LS1088A RDB Errata

Version 15

This document details all known board errata for the LS1088A RDB.

E-00001: DDR4 Selection for Interposer (LS1043A)

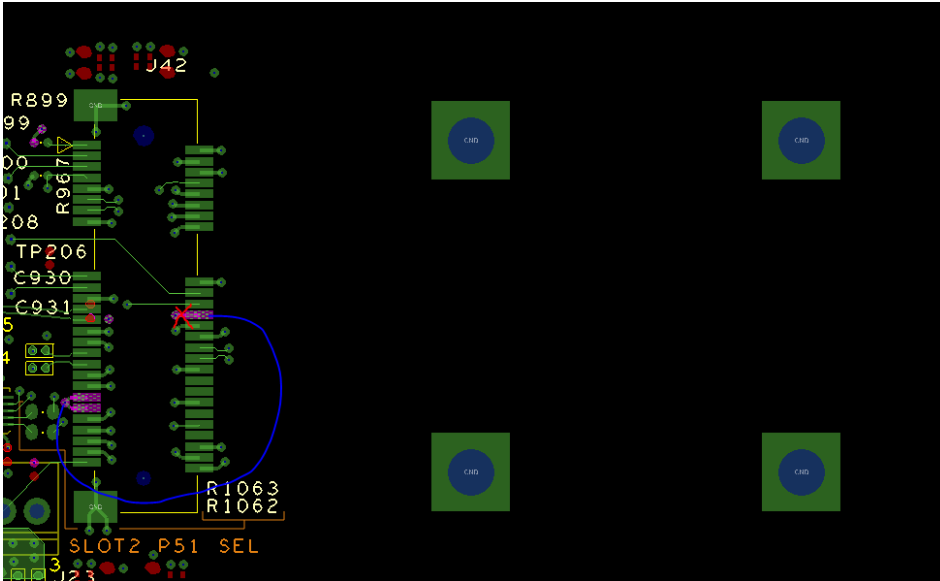
Description: LS1043A requires “cfg_dram_type=0” to select DDR4, the opposite that of the LS1088.

Impact: DDR will not work.

Workaround: Convert R1095 from a pullup to a pulldown.

1. Remove R1095, reinstall with pin 1 on the bottom pad and pin 2 free.
2. Connect R1095 pin 2 to ground at location shown.

Fix: All Rev A boards have had the above rework instructions applied. A permanent fix will be done on PCB Rev. B where the CPLD will drive the correct value based on the device type used (LS1043 or LS1088).

E-00002: WiFi Cards May Short Power Rails.

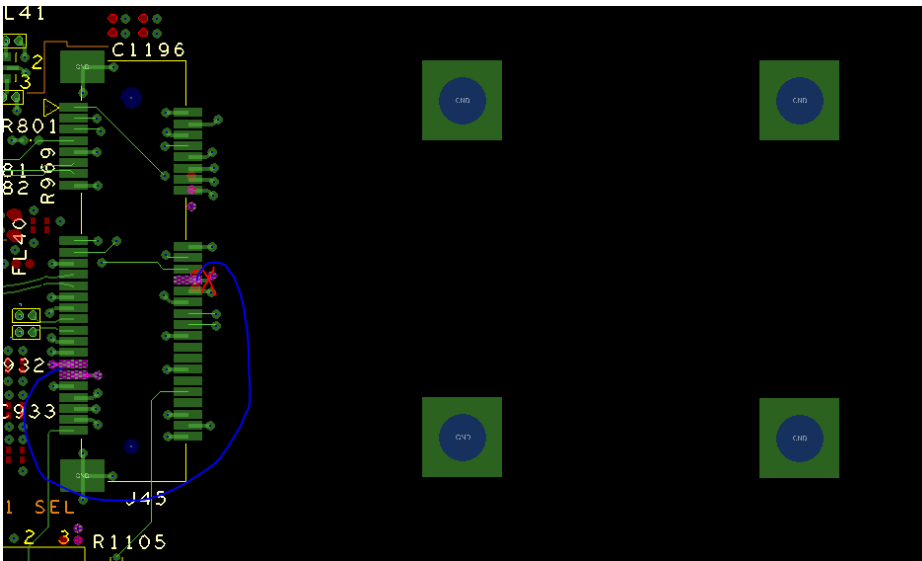
Description: Certain WiFi cards connect 3V3SB and 3V3.

Impact: Installing such cards causes the system to incorrectly power-on.

Workaround: Modify J42 and J45 as follows:

1. Cut trace between pad and via at J42 pin 24 (BEFORE ASSEMBLY) –or– Lift J42 pin 24 and isolate from pad with Kapton tape (AFTER ASSEMBLY).
2. Wire from J42 pin 24 to J42 pin 39/41 (shown in blue).

3. Cut trace from J45 pin 24 to via (red X).
4. Wire from J45 pin 24 to J45 pin 39/41 (shown in blue).

Fix: All Rev A boards have had the above rework instructions applied. Will be fixed on PCB Rev. B.

E-00003: LTC3882 at incorrect I2C address.

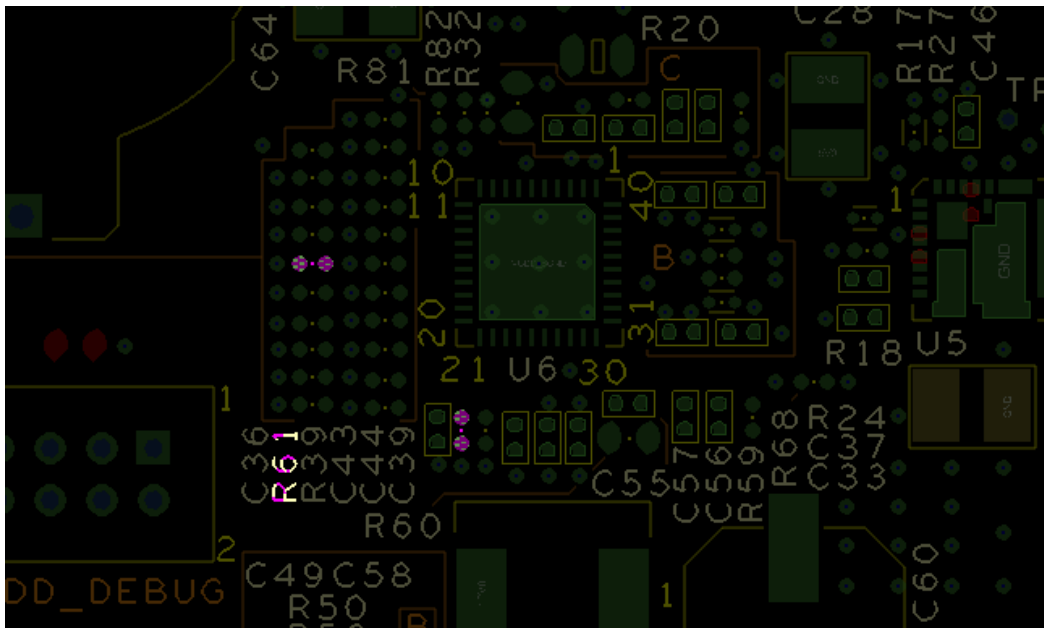
Description: The LTC3882 I2C (PMBus) address should be 0x63. It is currently at 0x66 and cannot be accessed due to the CPLD I2C address (0x66).

Impact: Processor cannot access LTC3882 for PMBus VDD setup, or monitoring.

Workaround: 1. Change R69 to 4.32K
2. Change R61 to 10K.

Fix: All Rev A boards have had the above rework instructions applied.
Will be fixed on schematic Rev A1 and PCB Rev. B.

E-00004: LTC3882 Components are non-optimized.

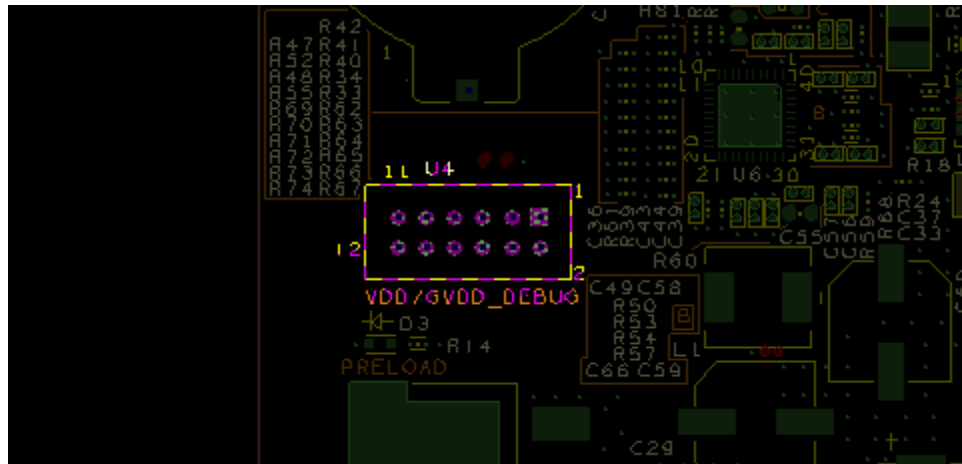
Description: LTC3882 schematic uses non-optimized components.

Impact: Performance is adequate but may exhibit issues under high-performance demands.

Workaround: Change components as follows:

Component	Was	Change To
R58	10.7k	3.48k 1%
C54	470pF	330pF
C50	470pF	1000pF
C53	5pF	10pF
R56	52.3k	30.1k 1%
R59	6.34k	3.48k 1%
C56	470pF	330pF
C55	2pF	10pF
R60	102k	30.1k 1%
C57	220pF	1000pF

Fix: All Rev A boards have had the above rework instructions applied. Will be fixed on schematics rev A1 or later.

E-00006: No clocks on miniPCIe with Certain Adapters

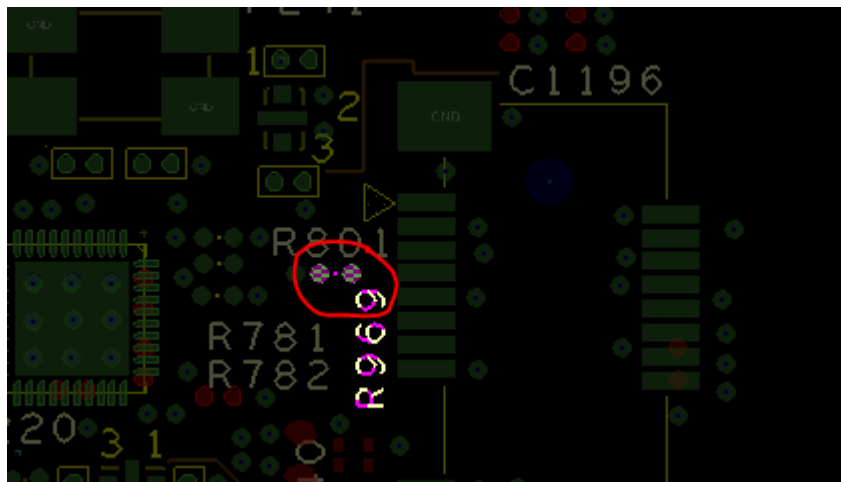
Description: Using some miniPCIe-to-PCIe adapters may not work as CLKREQ# is not asserted.

Impact: PCIe cards in an adapter are not usable.

Workaround: The clock driver has internal pulldowns; removing the pullups will all the clocks to always run.

1. Remove R967.

3. Remove R969.

Fix: All Rev A boards have had the above rework instructions applied. Will be fixed on schematics rev A1 or later.

E-00007: QSPI Emulator Header is Incorrect

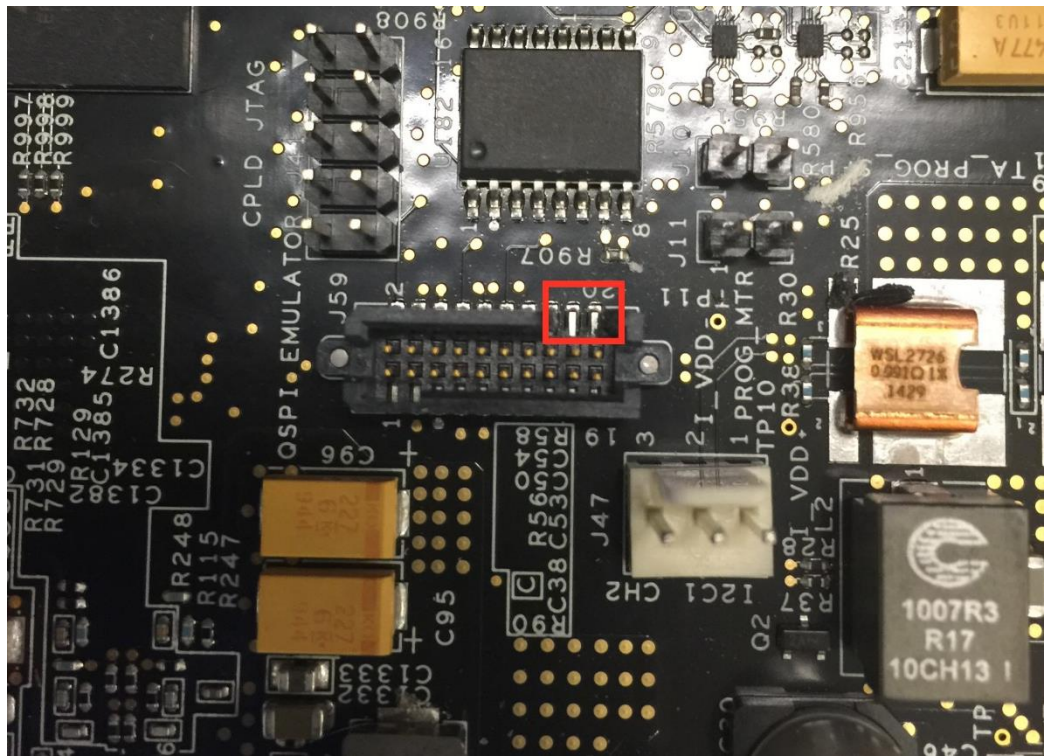
Description: The pinout of J59 does not match the DediProj QSPI emulator

Impact: Emulator is not usable.

Workaround: Pin 1 should be diagonally opposite the alignment key. There are two possible workarounds:

1. Remove J59 and reinstall rotated 180 degrees. If possible, rotate prior to board assembly.
2. Use cutters to remove part of the sidewall of J59. The width should be two pins worth:

Fix: Install the part such that the mechanical key is opposite pin 1.
Note: schematics and boards are all correct, this is an assembly issue.

E-00010: JTAG Header Shorted

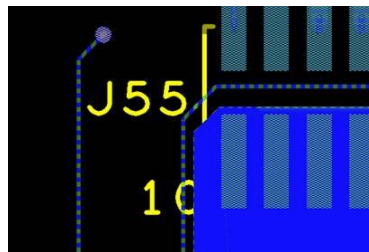
Description: A schematic net is misplaced, causing all even JTAG header pins to be shorted.

Impact: JTAG is unusable; processor will not exit reset.

Workaround: 1.) Remove J55. Isolate pins 2, 4, 6, 8, and 10. Reattach J55 and secure with epoxy as needed.

2.) Remove R290.

3.) Perform the following mods, routing wires through the BH8 Mounting Hole:

3a. Connect J55 pin 2 (JTAG_TMS_CON) to R835, pin 2 (DUT_TMS)

3b. Connect J55 pin 4 (JTAG_TCK_CON) to R855, pin 2 (DUT_TCK)

3c. Connect J55 pin 6 (JTAG_TDO_CON) to R854, pin 2 (DUT_TDO)

3d. Connect J55 pin 8 (JTAG_TDI_CON) to R853, pin 2 (DUT_TDI)

3e. Connect J55 pin 1 (OVDD) through a 100 ohm resistor to OVDD at R739, pin 1. Secure the 100 ohm resistor to the PCB using epoxy as needed.

3f. Connect J55 pin 10 (JTAG_RST_B) to nearby via (above letter J in J55):

Fix: Move misplaced schematic net to eliminate short.

E-00013: TDM Slot Not Working

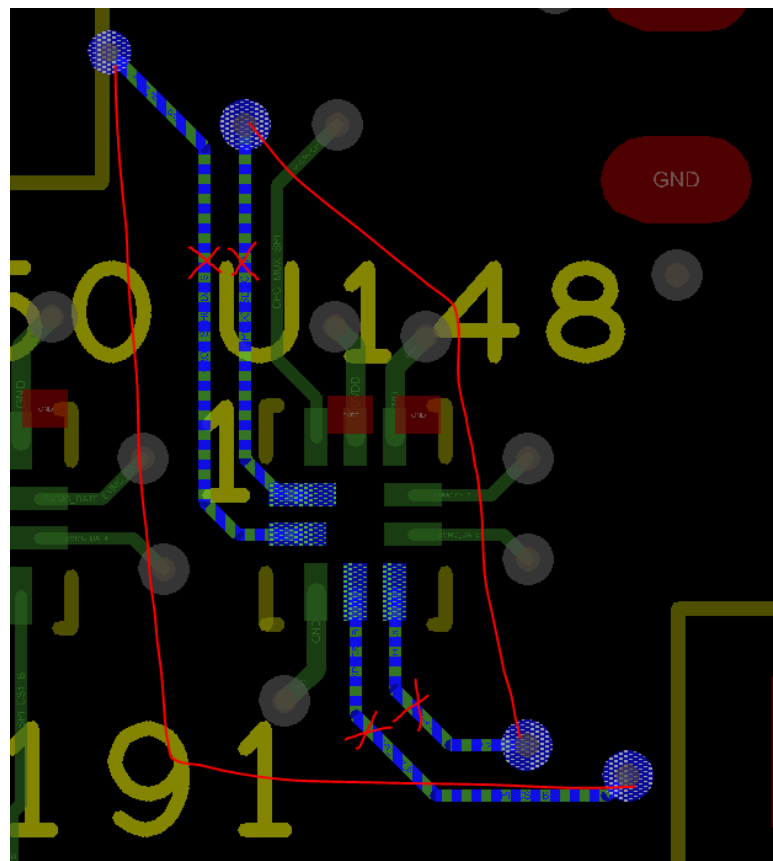
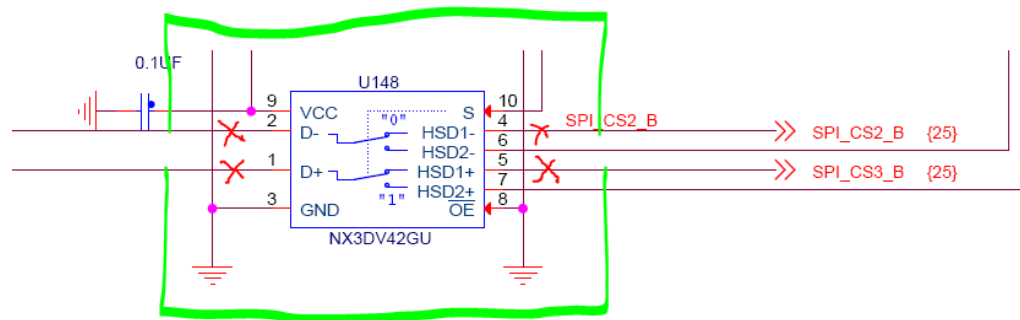
Description: The two SPI chip selects used for TDM (SPI_CS2_B and SPI_CS3_B) pass through a mux with sufficient series resistance to cause issues in the weak-drive voltage translation devices (NTB0104BQ). The CS signals oscillate, or remain in the previous drive level.

Impact: The TDM Riser card will not work.

Workaround: **NOTE:** This workaround will disable use of the on-board eMMC device.

The workaround requires wiring across the CS pins that were muxed in U148:

Fix: Since TDM only works on systems which must be opened (and the PCIe riser adapter removed), the optimal solution is to use two 1x3 “berg” headers for zero resistance.
